TECHNICAL REPORT

Rocker cover gasket choice
in IVECO 2.3 diesel engines.
Part numbers 11096000 and
11121300

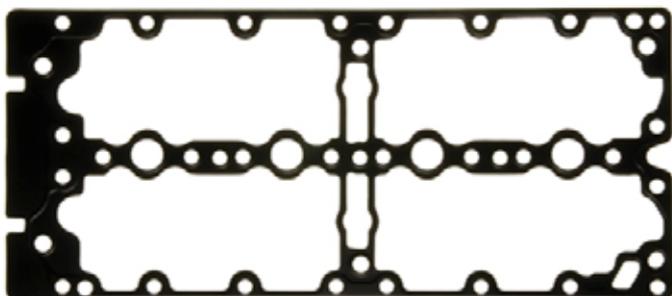
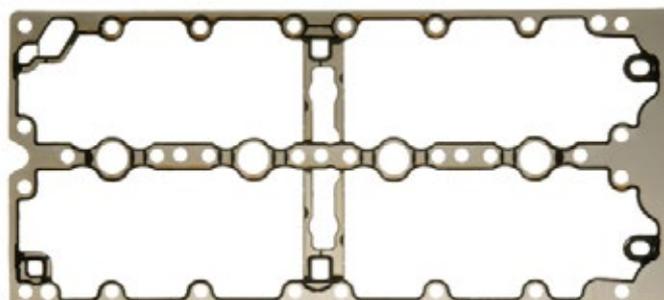
If this number is unknown, the gasket can also be chosen according to its material, shape and thickness:

Part number 11121300
 Rubber-covered steel
 Thickness: 0.35 mm

Part number 11096000
 Aluminium
 Thickness: 1.5 mm
